New Mexico Oil Conservation Division approval and conditions listed below are made in accordance with OCD Rule 19.15.7.11 and are in addition to the actions approved by BLM on the following <u>3160-4 or 3160-5</u> form.

30-045-34471 UTE MOUNTAIN UTE #078

HUNTINGTON ENERGY, LLC

Huntington Energy, LLC. Tribal Lease: I-22-IND-2772 Well: UMU #78 Location: 1075' FSL & 1340' FWL Sec. 16, T. 32 N, R. 14 W. San Juan County, New Mexico

Ute Mountain Ute # 78

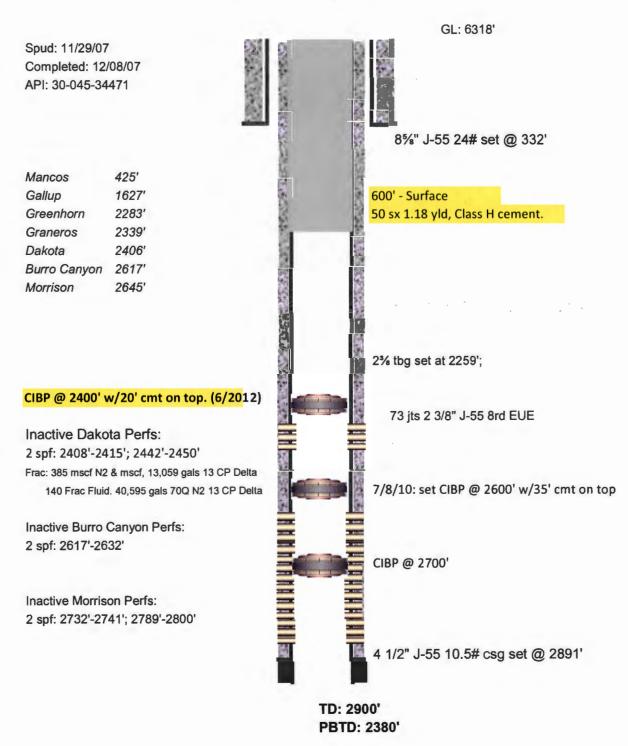
- Add a Graneros/Dakota plug 2390'-2290'. OCD Graneros pick @ 2340'.
- Add a Gallup plug 1672'-1572'. OCD Gallup pick @ 1622'.

6d. As per OO#2.G.2.iii, Bridge plugs must have a minimum of 50' of cement placed above them, 35' if a dump bailer is used. The plug at 2400' only has 20' of cement on top of it. This plug must be extended to the proper length. Please advise the BLM of your plans to meet this requirement.
